REMARKS

B. Drawings

During the course of Applicant's review of the specification and drawings in preparation for responding to the Official Action, Applicant discovered the informalities identified below in the drawings. Accordingly, applicant requests permission to amend the drawings in the following manners:

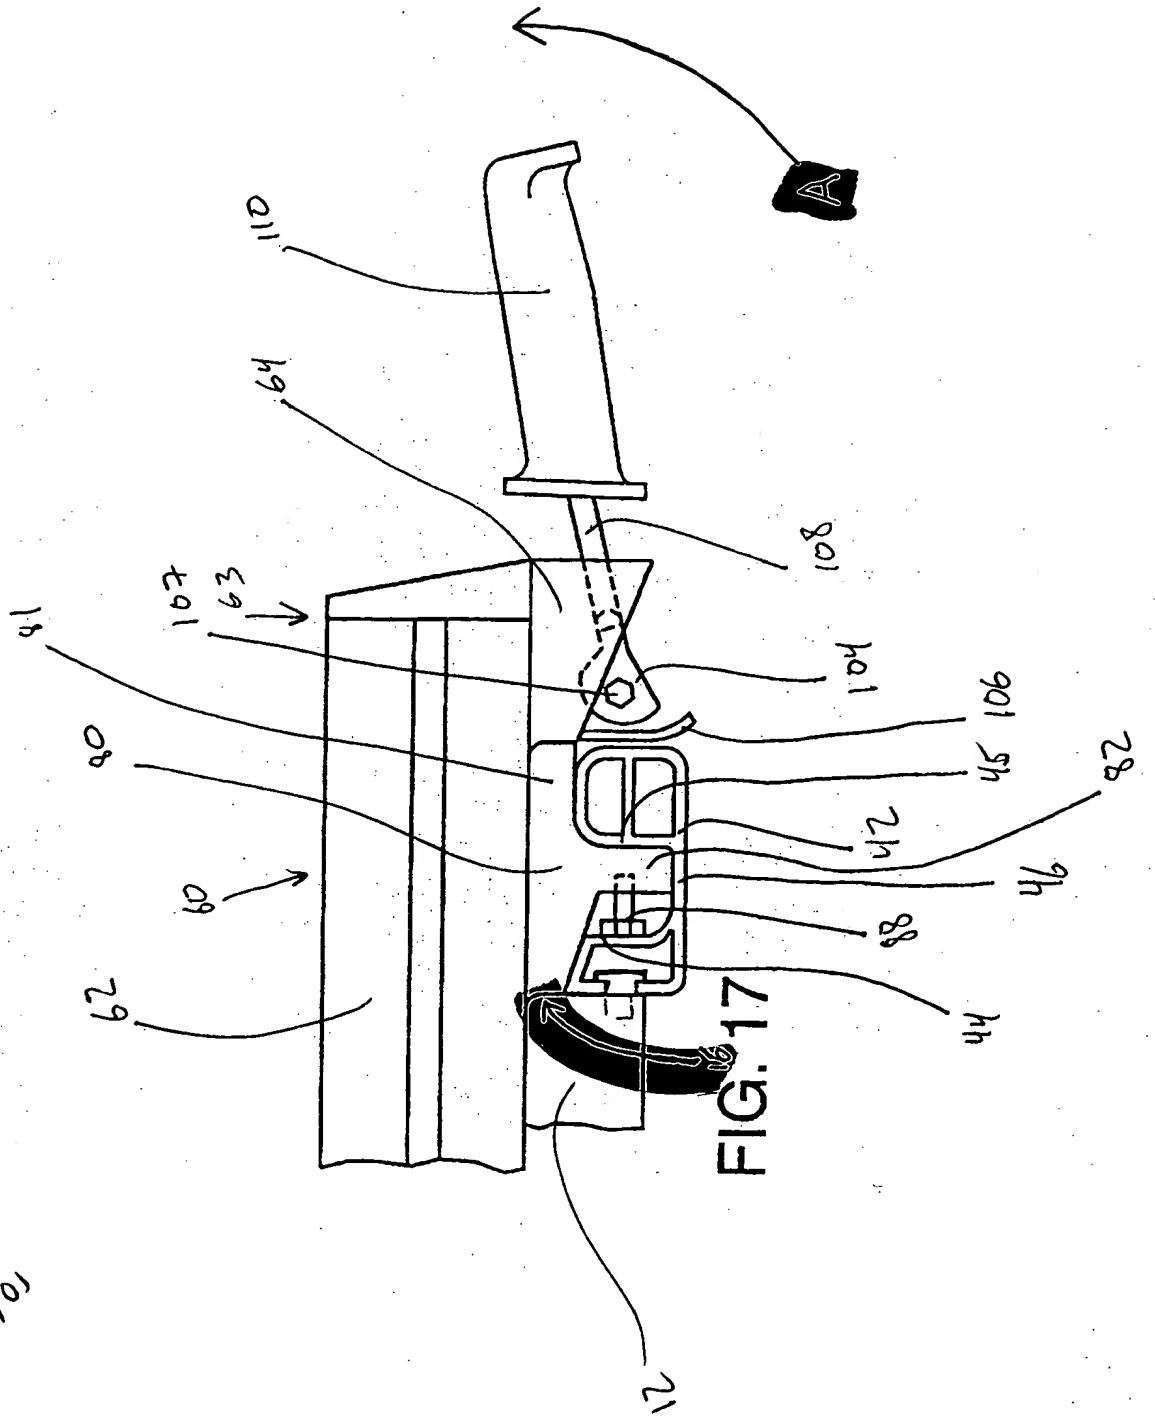
Figure 16: Reference number "64" lead line amended to terminate with an arrow and redirected to point to the proper element.

Reference number "88" lead lines both amended to terminate with an arrow.

Reference number "66" added with a lead line terminating with an arrow to show the element as supported in the original disclosure.

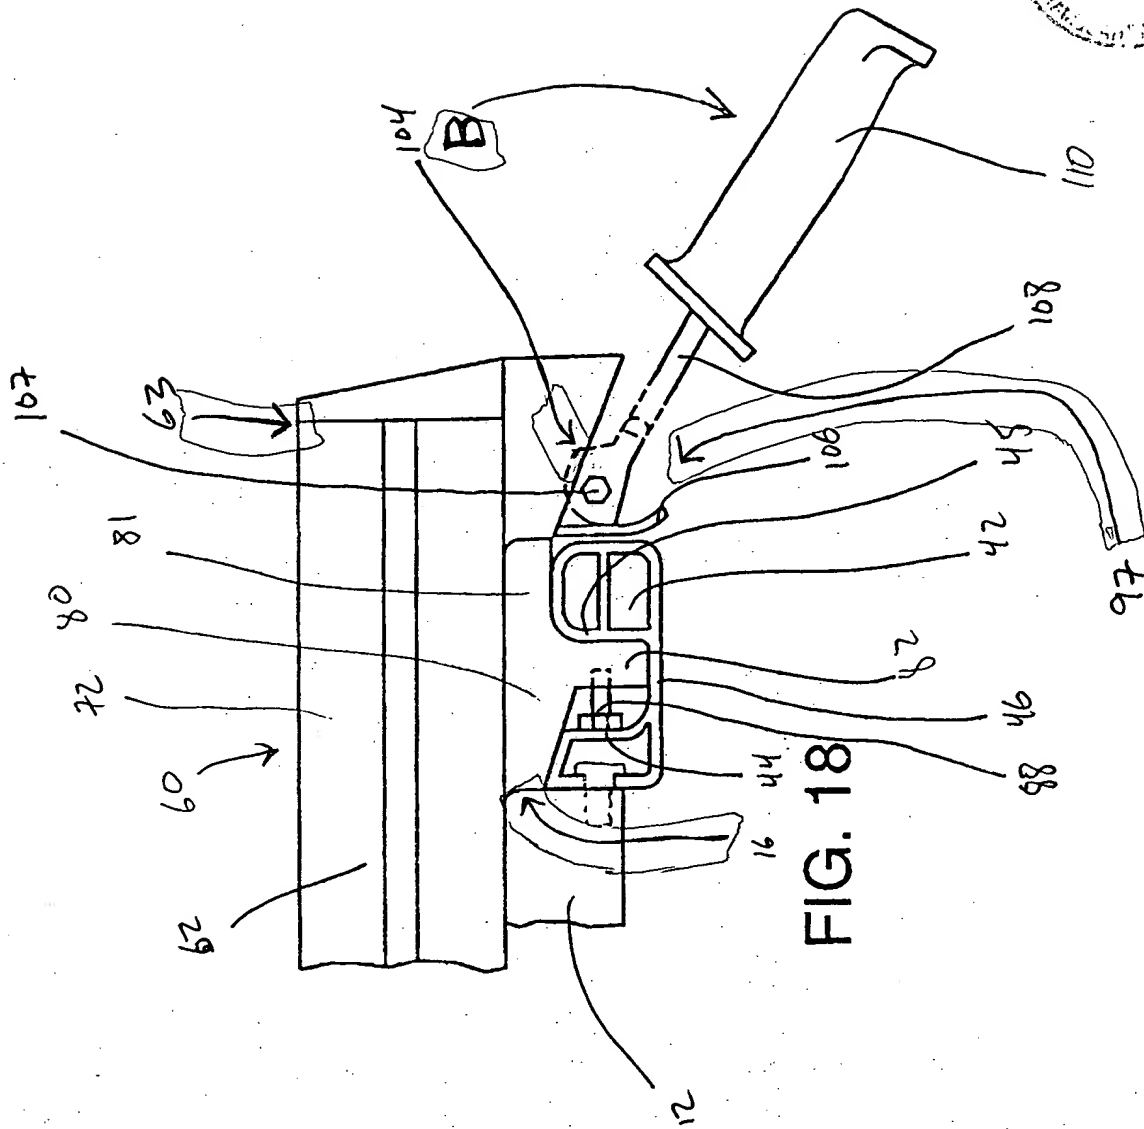
Figure 17: Reference number "16" lead line redirected to point to proper element surface.

Reference letter "A" added to the curved lead line terminating with an arrow to show the directional movement described in the original disclosure.

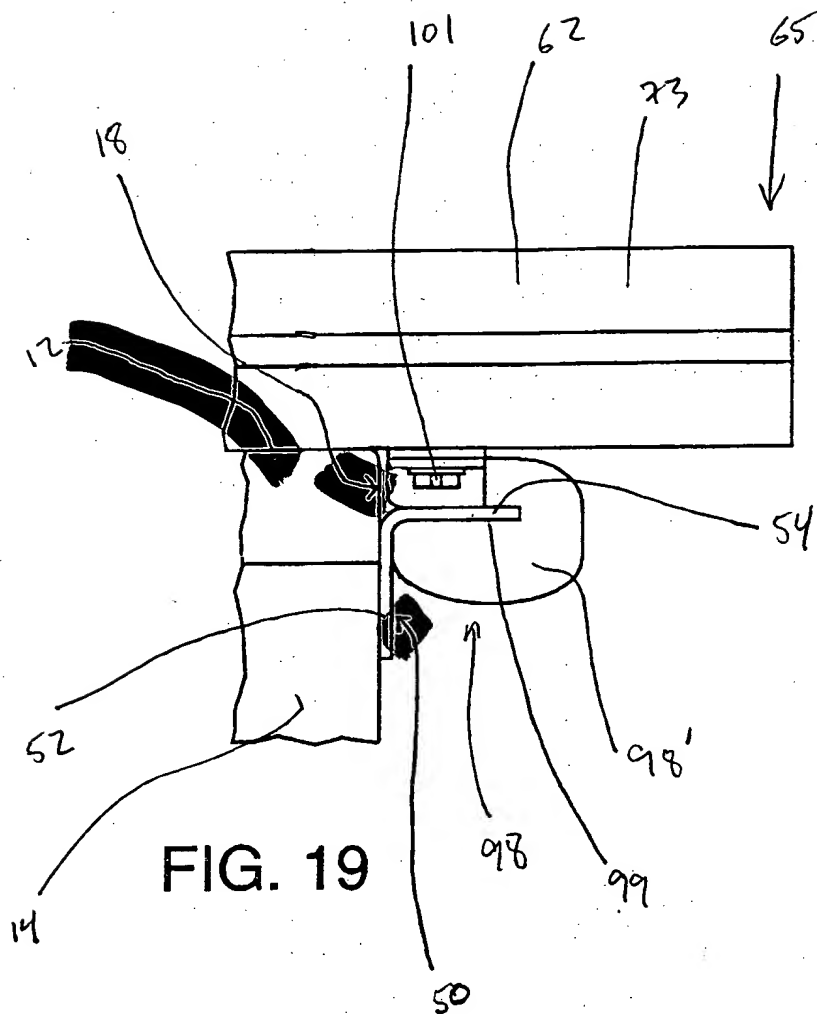
Figure 18: Reference number "16" lead line redirected to point to proper element surface.

Reference number "97" lead line redirected to point to the proper element.

Reference letter "B" added to the curved lead line terminating with an arrow to show the directional movement described in the original disclosure.

Reference number "104" lead line amended to terminate with an arrow.

Reference number "63" lead line redirected to point to the proper element.
